DOE/EIS-126-F

Final Environmental Impact Statement

**REMEDIAL ACTIONS AT THE FORMER
CLIMAX URANIUM COMPANY
URANIUM MILL SITE
GRAND JUNCTION, MESA COUNTY,
COLORADO**

VOLUME I - TEXT

FIGURE 4.8
GENERALIZED CROSS-SECTION OF THE GEOLOGIC STRUCTURE
IN THE GRAND JUNCTION AREA

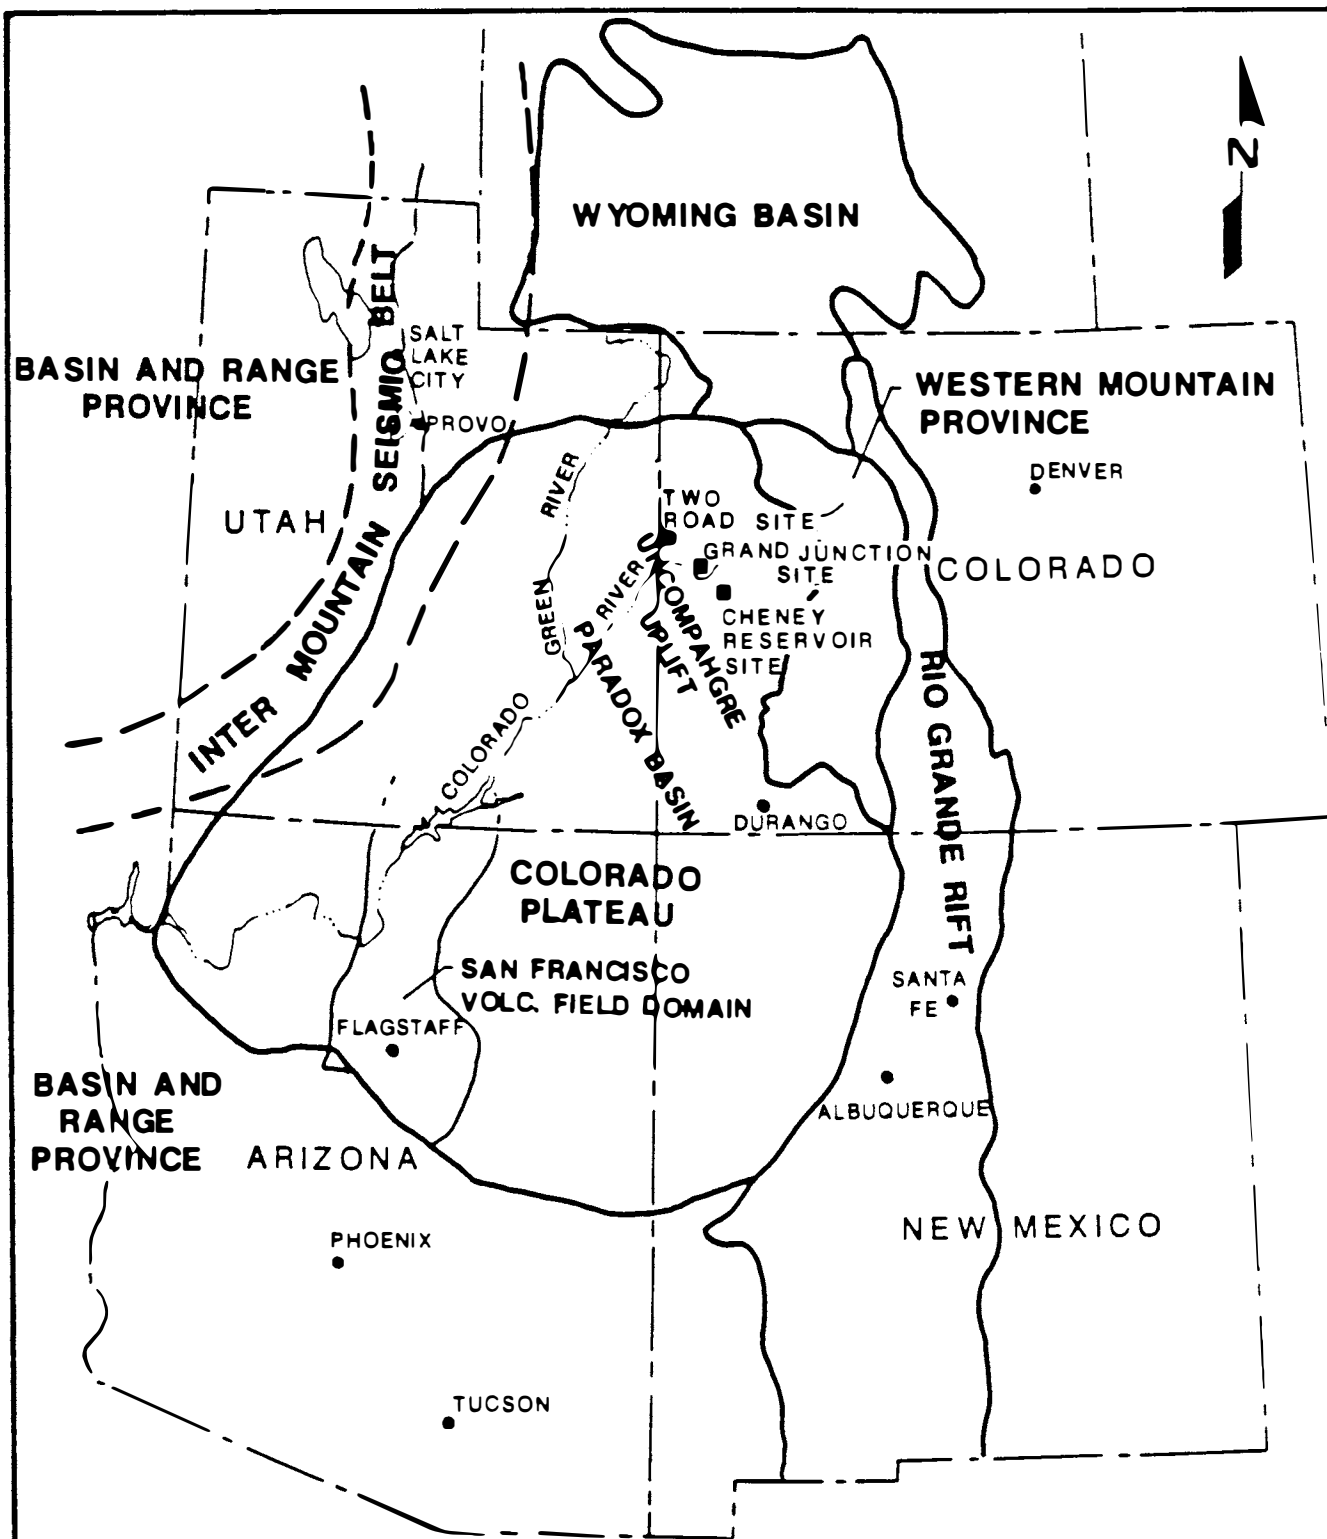
The pattern for the Precambrian schists, gneiss, etc., on Figure 4.8 is appropriate for sedimentary rocks only, not metamorphics. Standard patterns for metamorphics are available and should be used (25).

- 6.4.19 | Page 61, 4.2.4: The number of cubic yards of borrow material should be included here.
- 6.19.1 | Page 73, Figure 4.8: The pattern for the Precambrian schists, gneiss, etc., is appropriate for sedimentary rocks only, not metamorphics. Standard patterns for metamorphics are available and should be used.

Agreed. Figure 4.8 has been revised.

FIGURE 4.16
MAJOR HIGHWAYS IN THE VICINITY OF GRAND JUNCTION

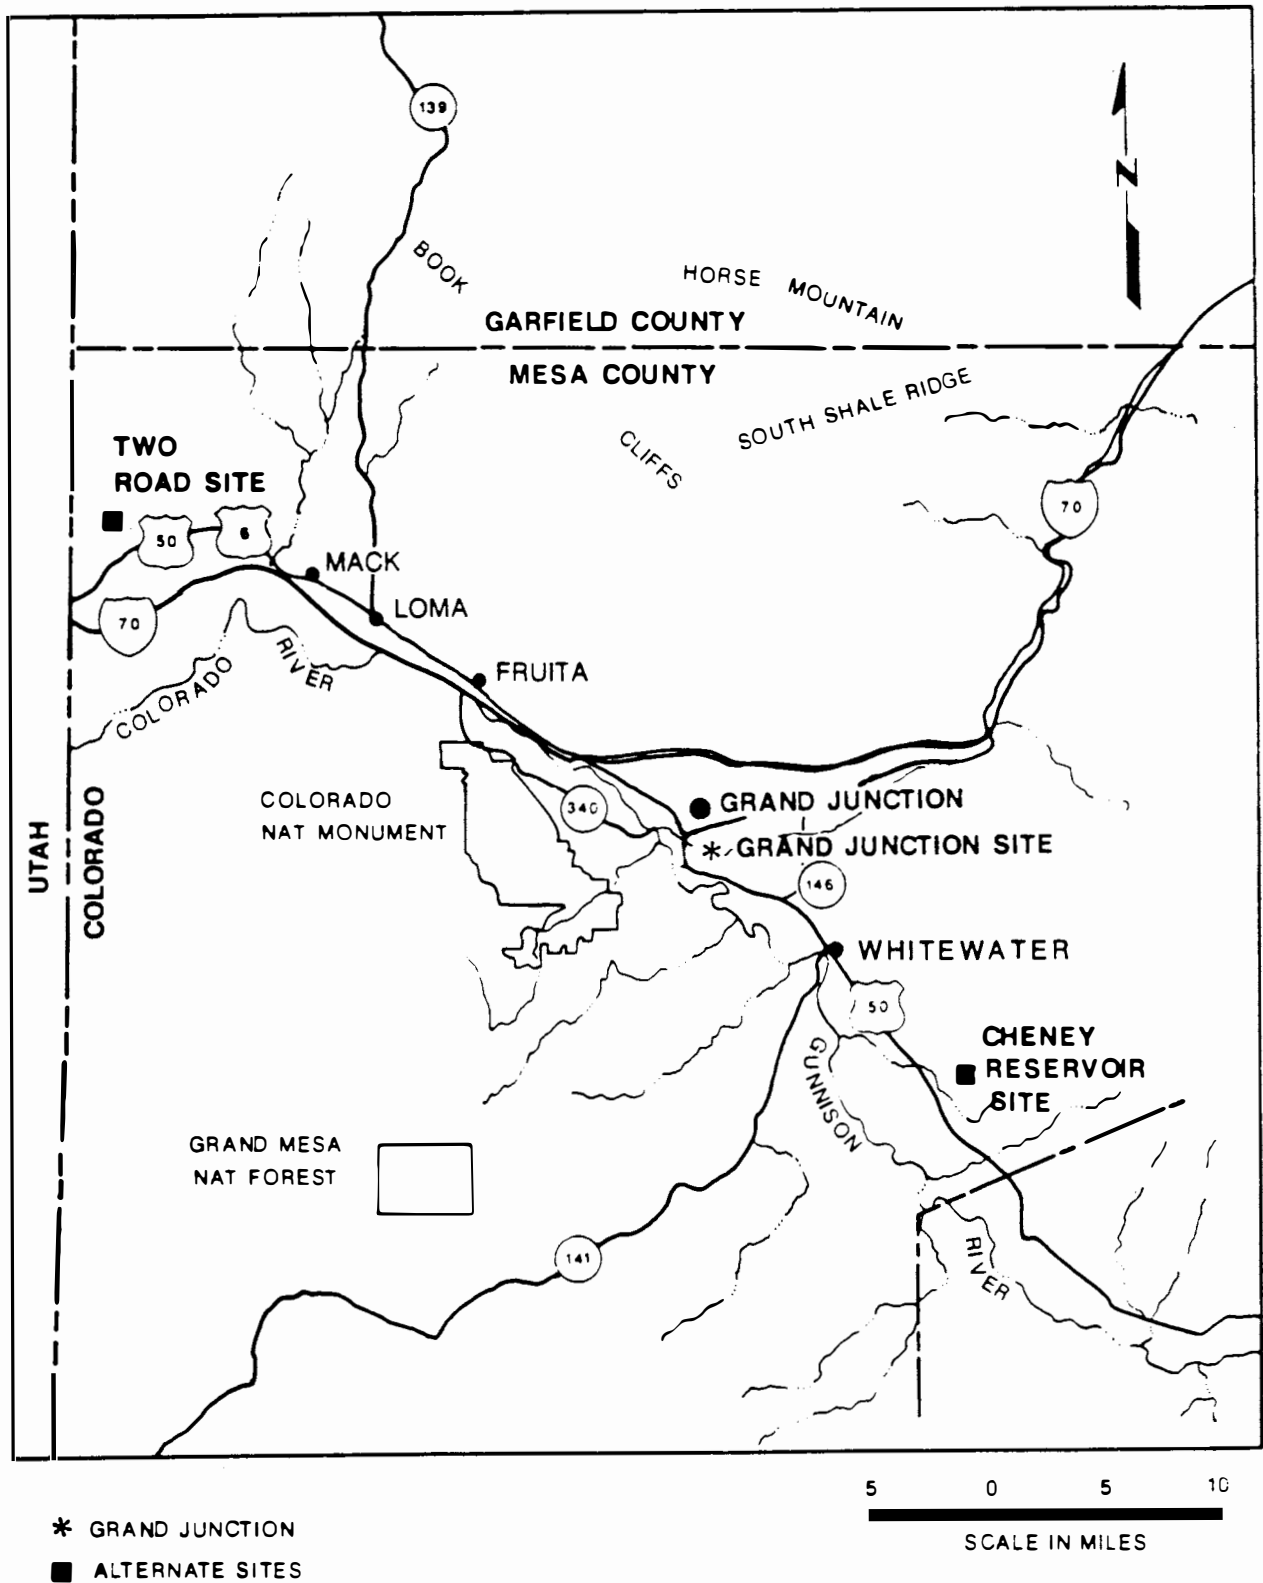
Figure 4.16. 32 Road is mislabeled; State Highway (SH) 146 is now designated as SH 141; 29, 30 and 31 Roads do not cross the Colorado River (26).

Figure 4.16 has been revised.

FIGURE 6.2
POTENTIALLY ACTIVE FAULTS ASSOCIATED
WITH THE UNCOMPAHGRE UPLIFT

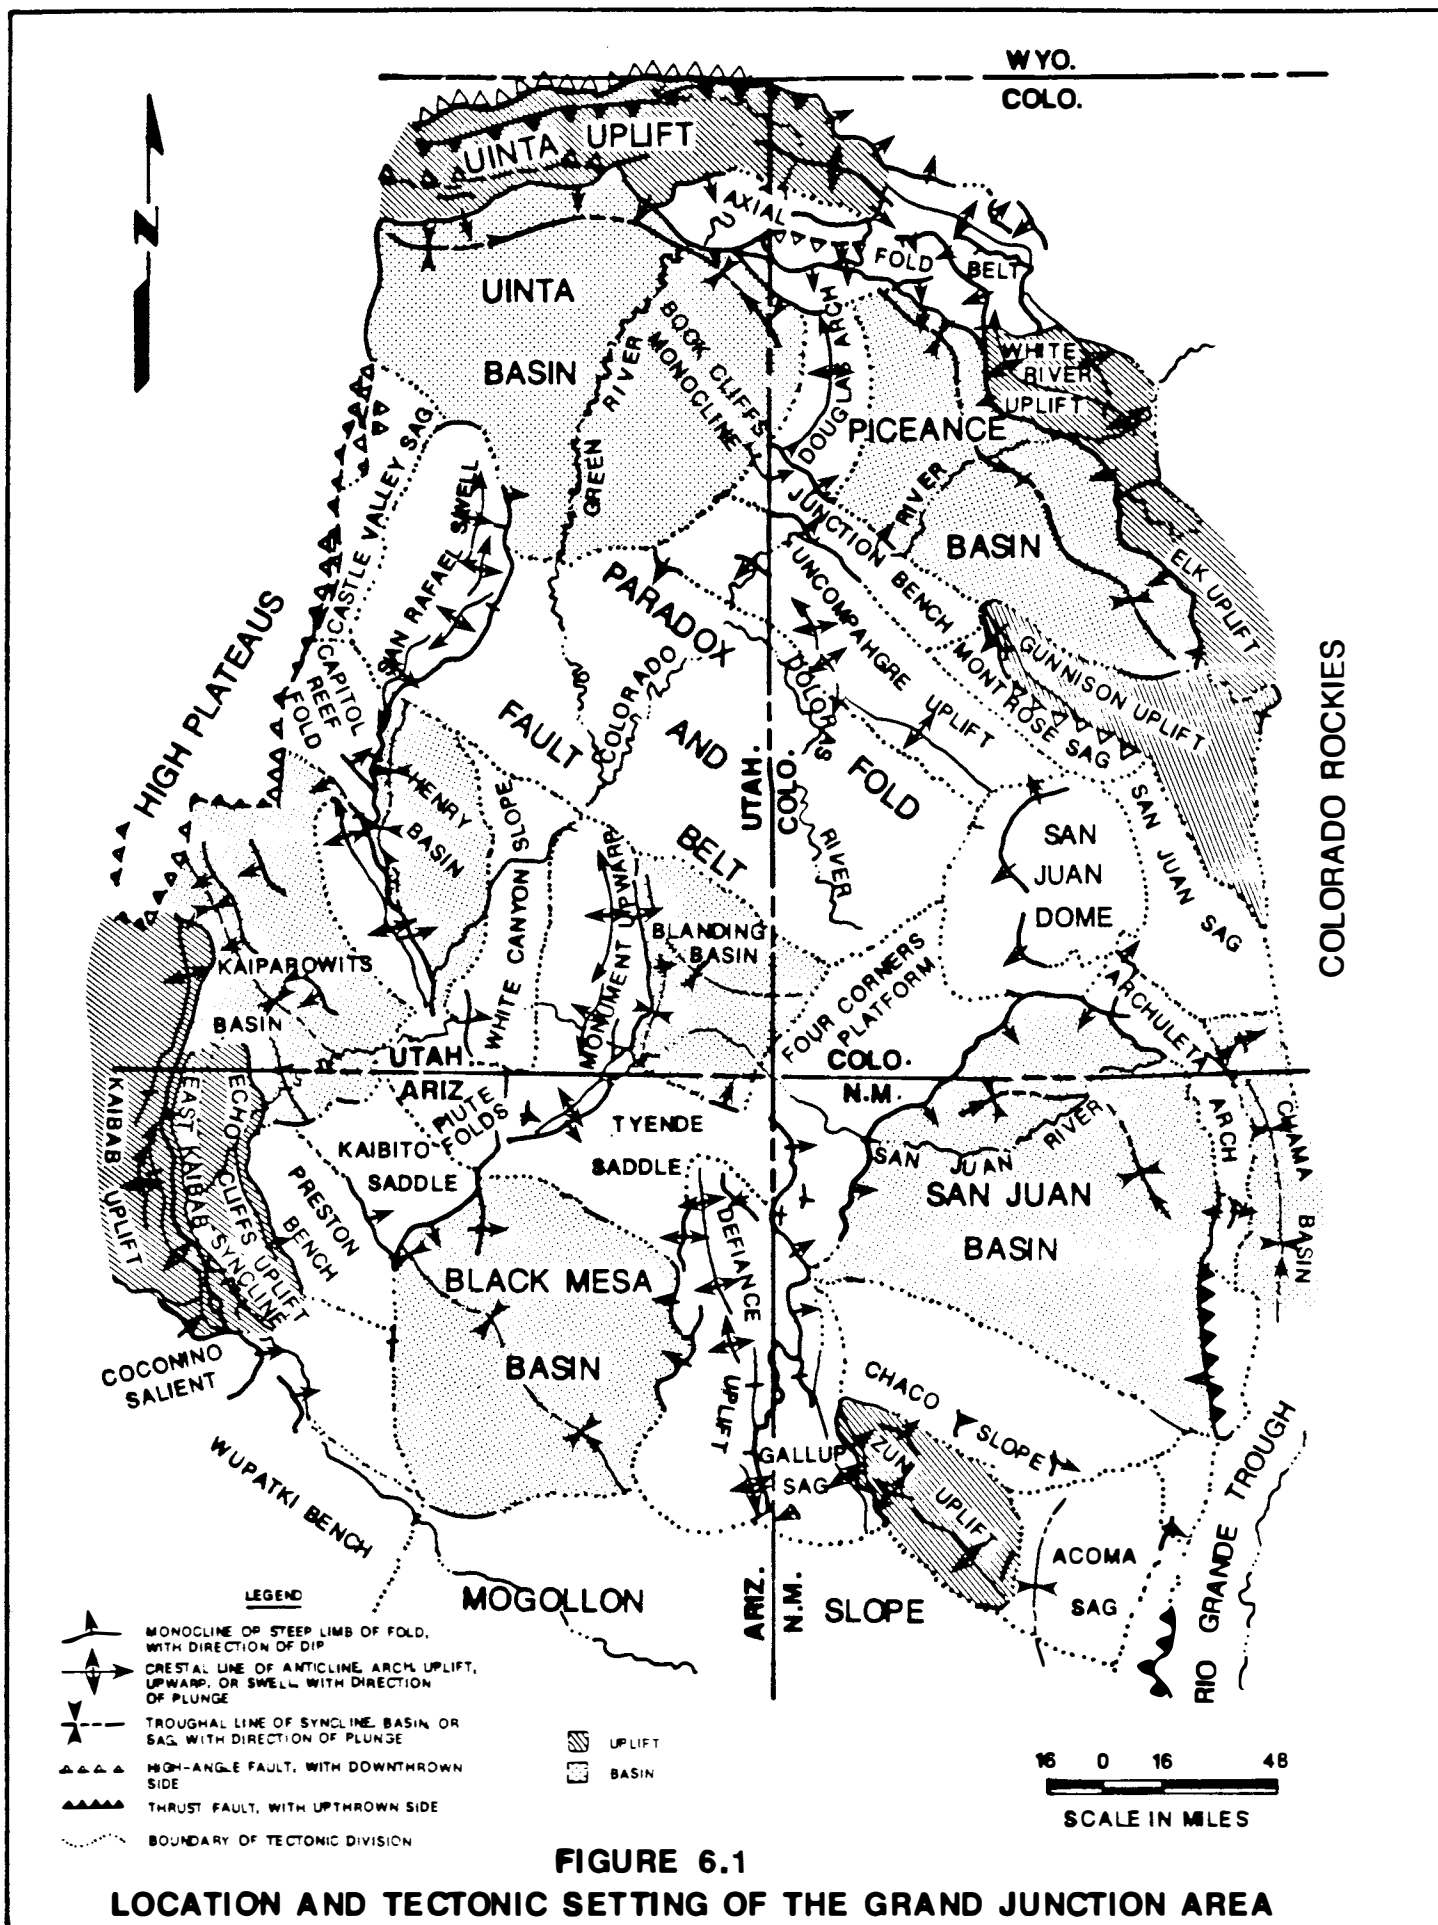
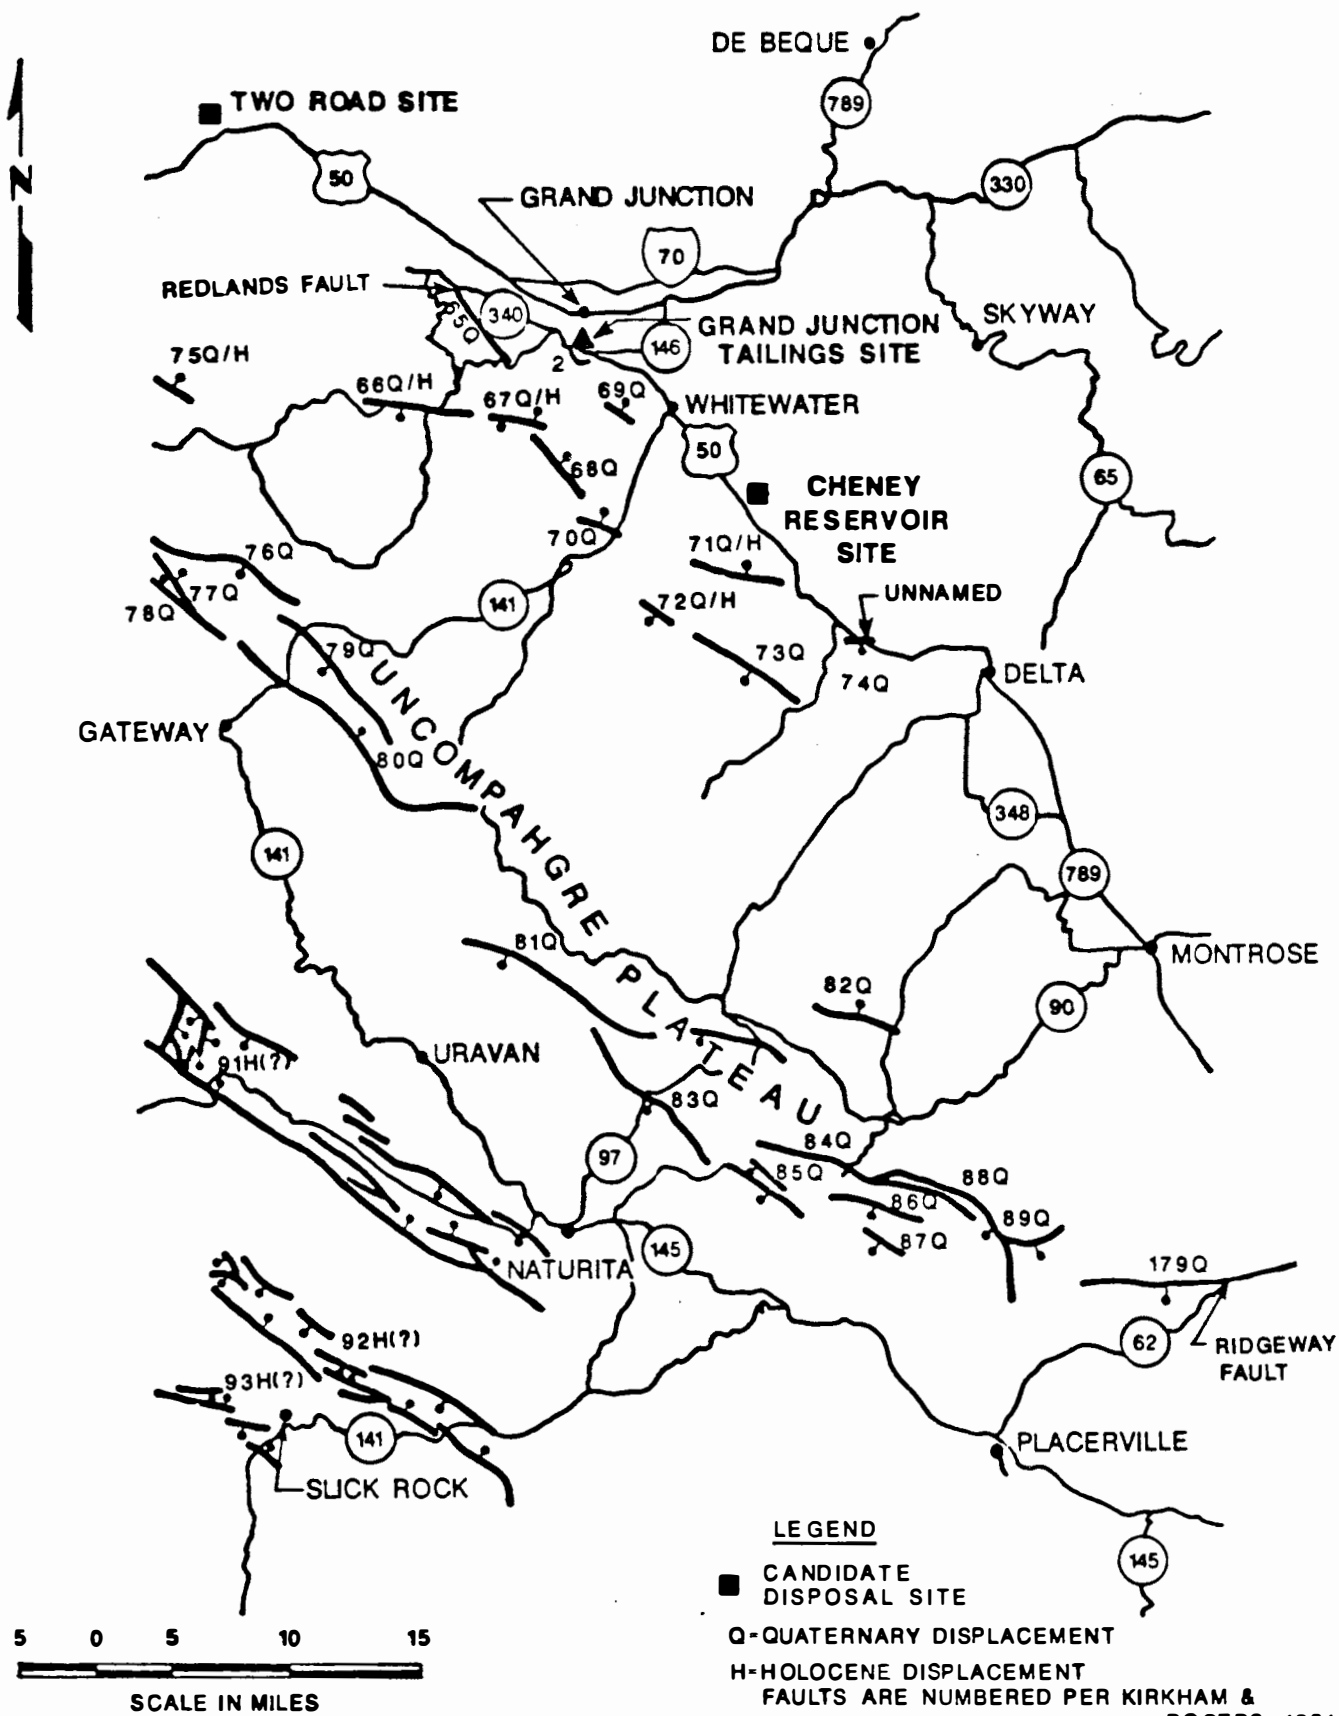
In Section E.2.1.3, Structure, and Section E.4.3.2.1, Uncompahgre Uplift, some descriptions of geologic structure that are discussed in the text are not labeled in the figures. Examples include the Redlands Fault, the Jacobs Ladder Fault complex, and the Book Cliffs monocline, which are discussed in the text but are not labeled in Figures E.2.3 or E.2.4. Also, the Ridgeway Fault and Fault No. 74 discussed on pages E4-13 are not shown on Figure E.4.3.3 (28).

Figure E.4.3.3 shows potentially active faults associated with the Uncompahgre Uplift. However, the map does not adequately convey local site conditions because the map covers too large an area. A more detailed, larger-scale map is necessary to properly characterize seismotectonic activity and/or prediction at the alternative sites (28).

The commentor is correct, although the need for modifying the figures and text and reissuing the entire appendix is obviated by the fact that the conclusions drawn from such additional information would not change. However, these figures have been modified and included as Figures 6.1 and 6.2.
